Contract Program: Technical Support for the Reactor Systems Branch (L1697/P2)

Subject of Document: Review of Proposed Modifications to Emergency Procedure
Guidelines for Anticipated Transients Without Scram Events

Type of Document: Technical Evaluation Report

Date of Document: November 1995

Figure 13. Core thermal power following level increase assuming that boron does not remix.

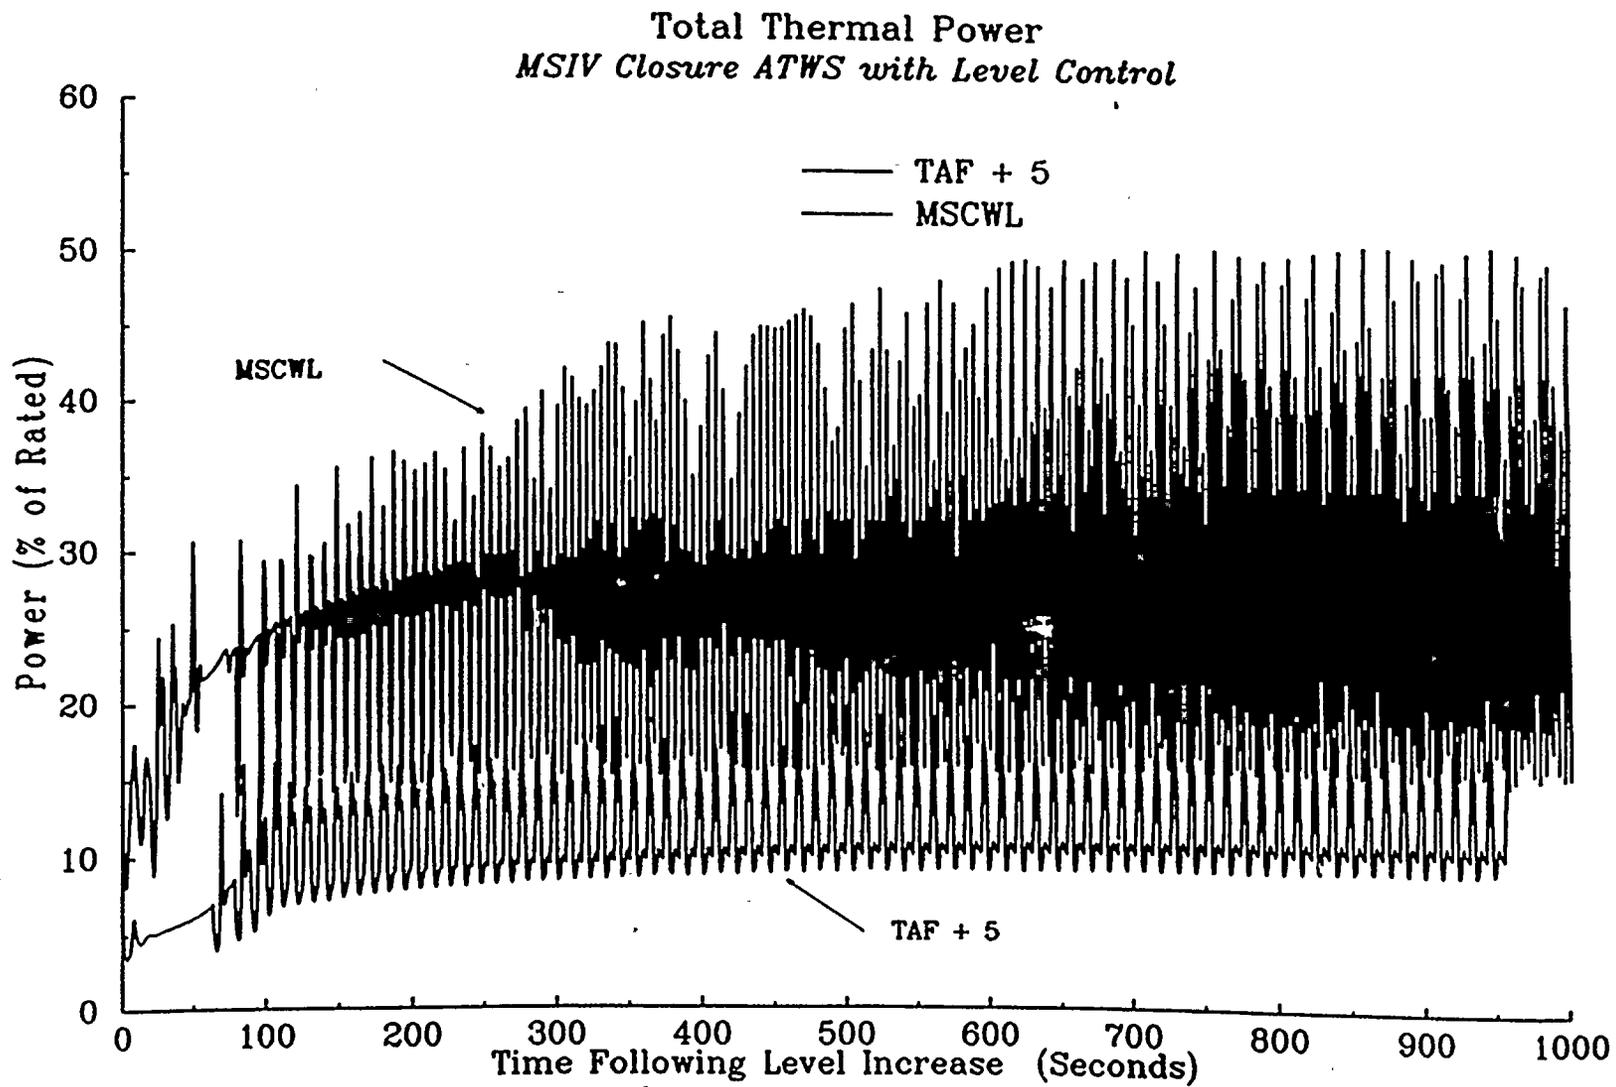
Figure 13 shows the core thermal power for the two level-control strategies if we assume that boron is not destratified when the level is raised. It can be observed from this figure that the power for the lower level strategy (MSCWL) is significantly higher than the power for the higher level strategy. This is due to the fact that the lower-level strategy has a smaller concentration of boron before the SLC injection begins to stratify; therefore, when the level is increased the flow increases and the power is higher than with the higher dissolved boron concentration of the higher-level strategy.

Figure 14. Recirculation flow following level increase assuming that boron does not remix.

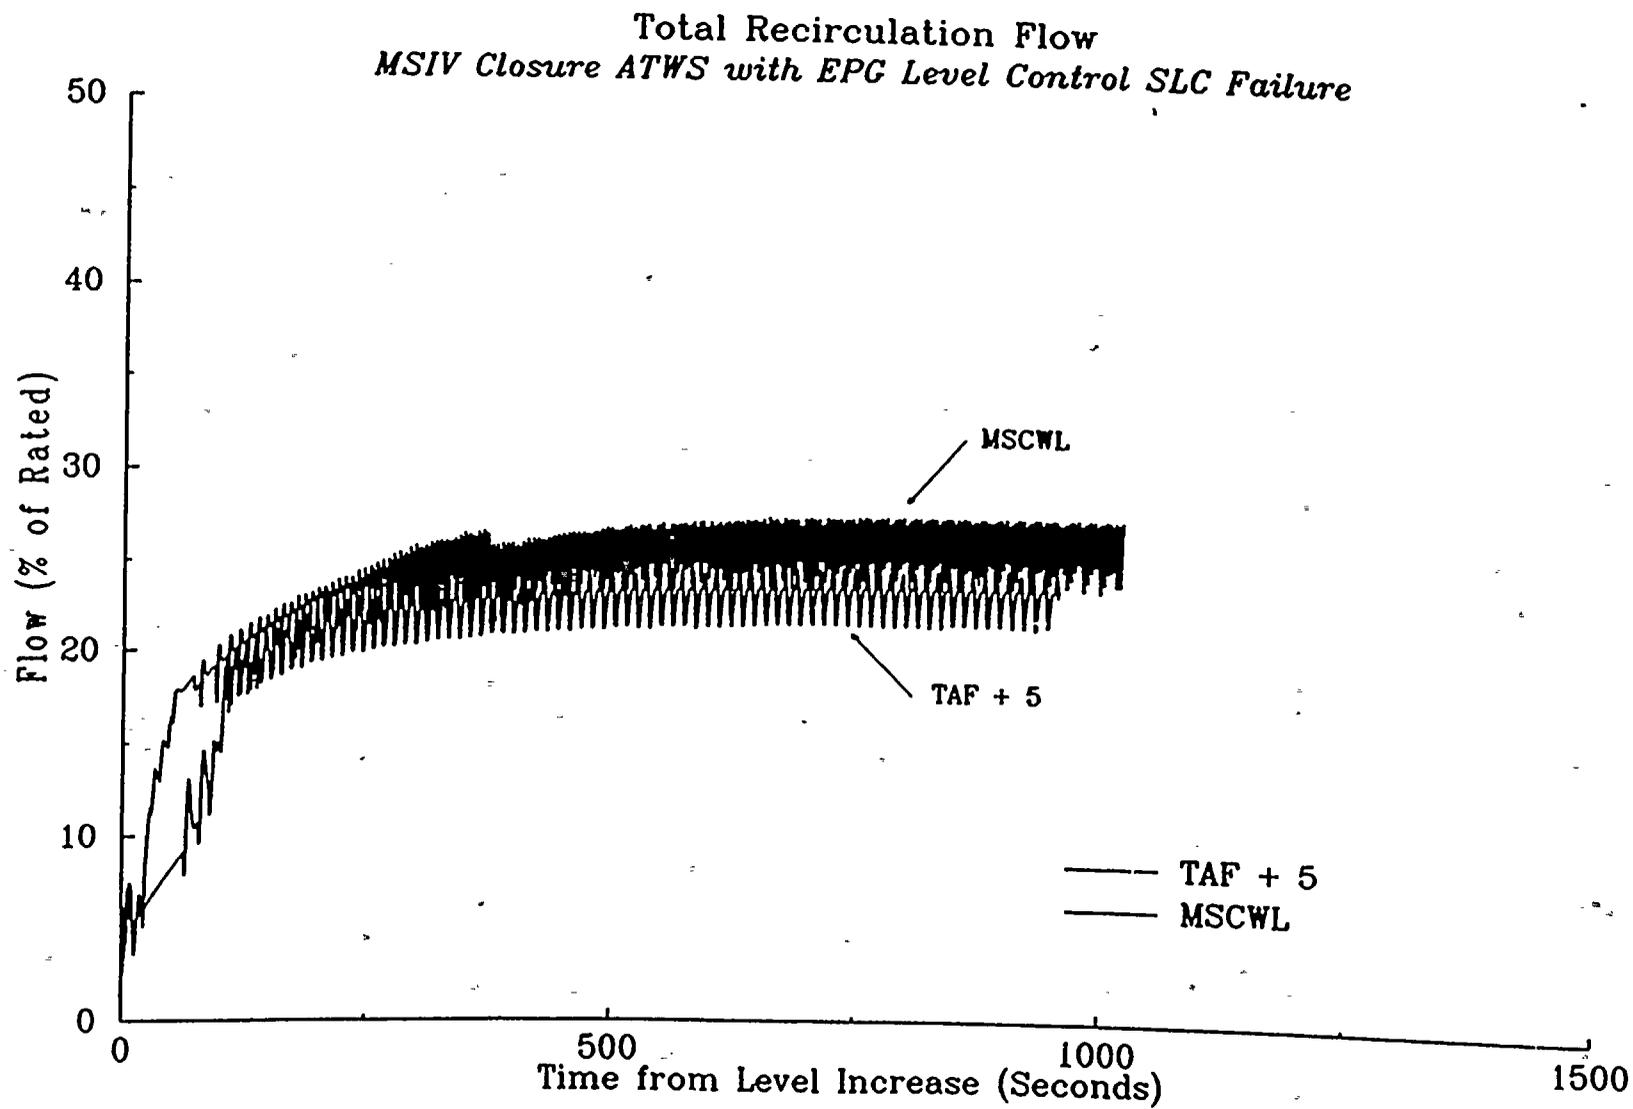
Figure 14 shows the flows reached after level increase (with failure to destratify) for both strategies. As it can be observed, both strategies reached approximately the same recirculation flow (greater than 20%) even though the power generation is quite different (see Fig. 13). This fact is not unusual and it indicates that the "natural circulation line" in the power to flow map is almost vertical, as expected. The calculations of Fig. 14 indicate that the reactor achieves a flow greater than 20% when the level is raised to remix the stratified boron; all available data indicates that stratified boron will remix at this high flow.

Figure 15. Suppression pool temperature assuming level increase without boron remixing at 1300 seconds.

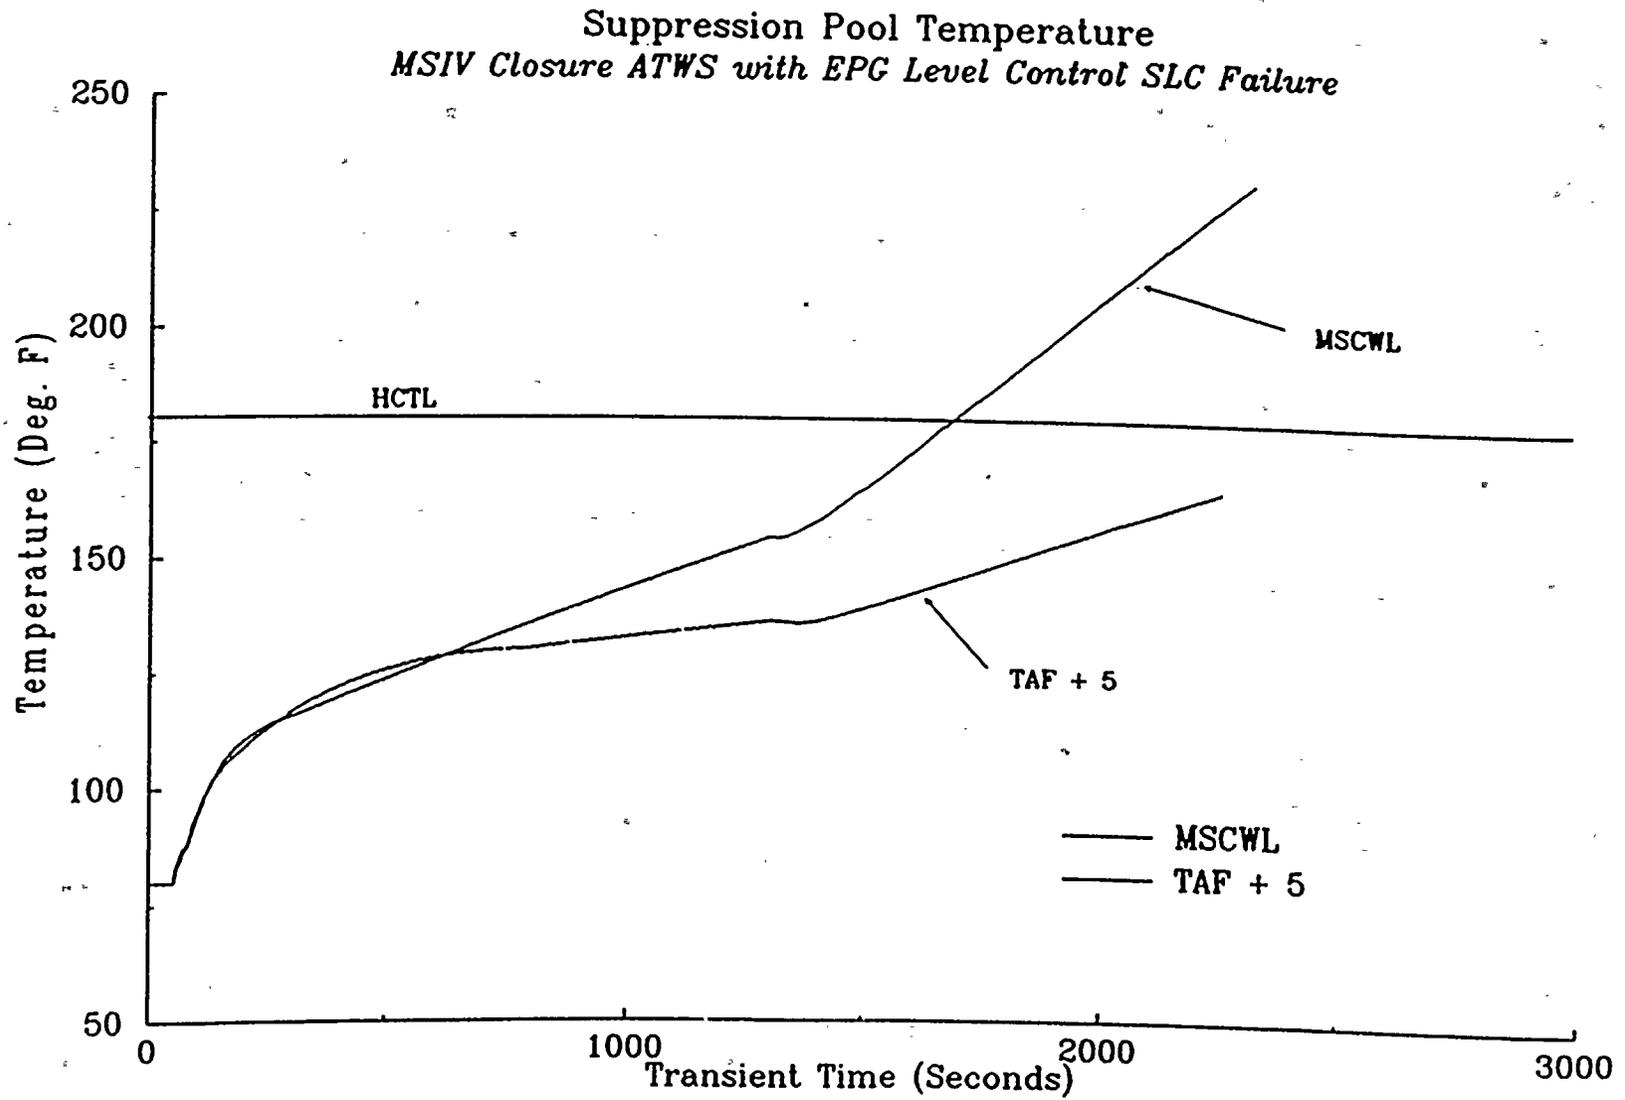
Figure 15 shows a comparison of suppression pool temperatures for the two level-control strategies when we assume that boron does not destratify and no additional boron is injected once the water level is raised. As seen in this figure, the higher-level strategy results in lower pool temperatures and more time before it reaches the HCTL (400 s for the MSCWL strategy versus 1400 s for the TAF + 5' strategy).

The calculations in Fig. 15 are extremely conservative; they not only assume that boron does not destratify, but also assume that no additional boron is injected once the level is raised. Figure 16 shows a slightly less conservative calculation, where the stratified boron is assumed not to remix, but we take credit for the additional boron that is injected by the SLC system after the level is raised and the flow increases back to 20%. When this additional boron injection is accounted for, the time available before HCTL is reached is increased significantly, and it provides more than the 10 minutes that may be required to remix the stratified boron.
